EARTHWORKS

February 19, 2016

Thank you for the opportunity to submit comments for consideration on the completeness review of the permit application submitted by Tintina for the Black Butte Project on December 15, 2015.

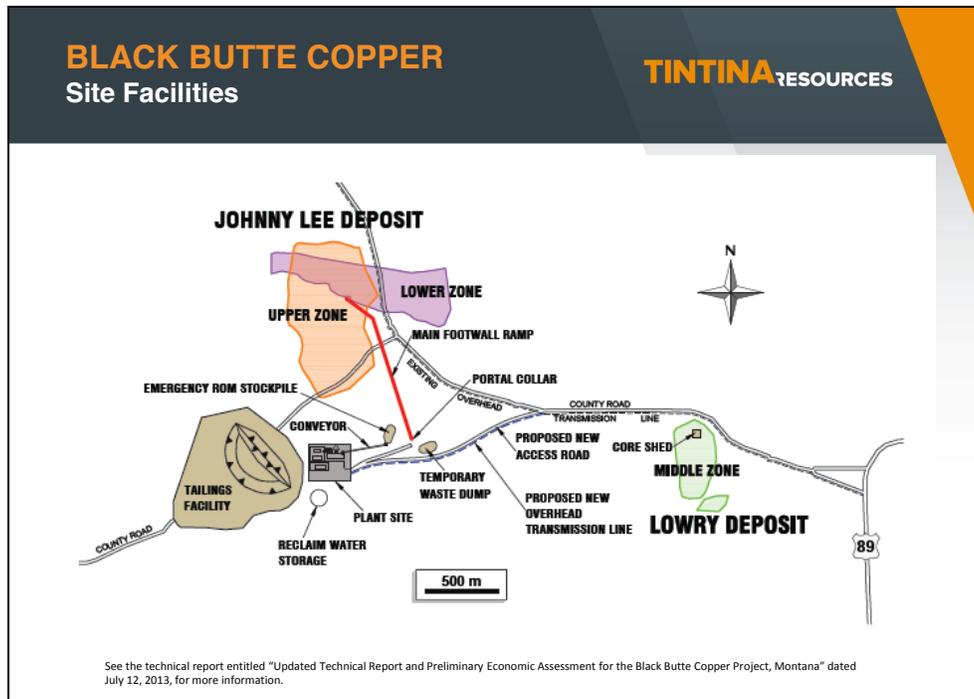
The permit application is missing information on the Lowry Deposit. The company has made it clear to investors that this deposit is part of its mining plans for the area, describing the Lowry Deposit as the middle zone in its project maps:

Section 1 should include information about the Lowry deposit and a description of the large-scale mineral system, as identified in this map (below) from Tintina, which the company identifies as the district-wide potential to extend mine life and establish a 50-year district. Maps and descriptions should be provided that identify Tintina’s land and mineral holdings related to the mining district. See: <http://www.tintinresources.com/assets/docs/ppt/corporate-presentation.pdf>
